Technical Service Bulletin

Topic	93 e-tron GT: converting high-voltage battery charger from 22kW to 11 kW
Market area	United States 444 Volkswagen of America, Inc. (6444)
Brand	Audi
Transaction No.	2078782/1
Level	EH
Status	Released for publishing
Release date	Aug 19, 2025

93 e-tron GT: converting high-voltage battery charger from 22kW to 11 kW

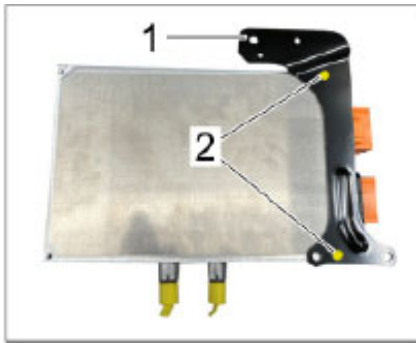
Both brackets of the 22 kW high-voltage battery charger (position 1) are removed (see following image).

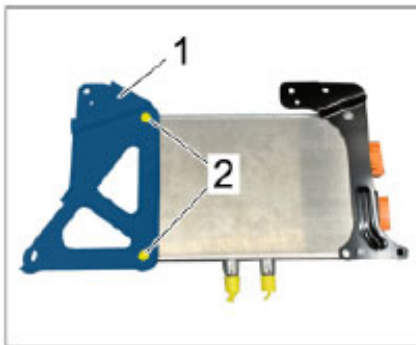
Fit one of the two previously removed brackets at position 1 (see following image) on the new 11 kW high-voltage battery charger using the new shorter (M6x18) bolts (see position 2). The tightening torque is 8 Nm.

b) Secure new bracket

The new bracket is fitted to the side facing away from the connector using the **new, shorter (M6x18)** bolts (see following image). The tightening torque is 8 Nm.
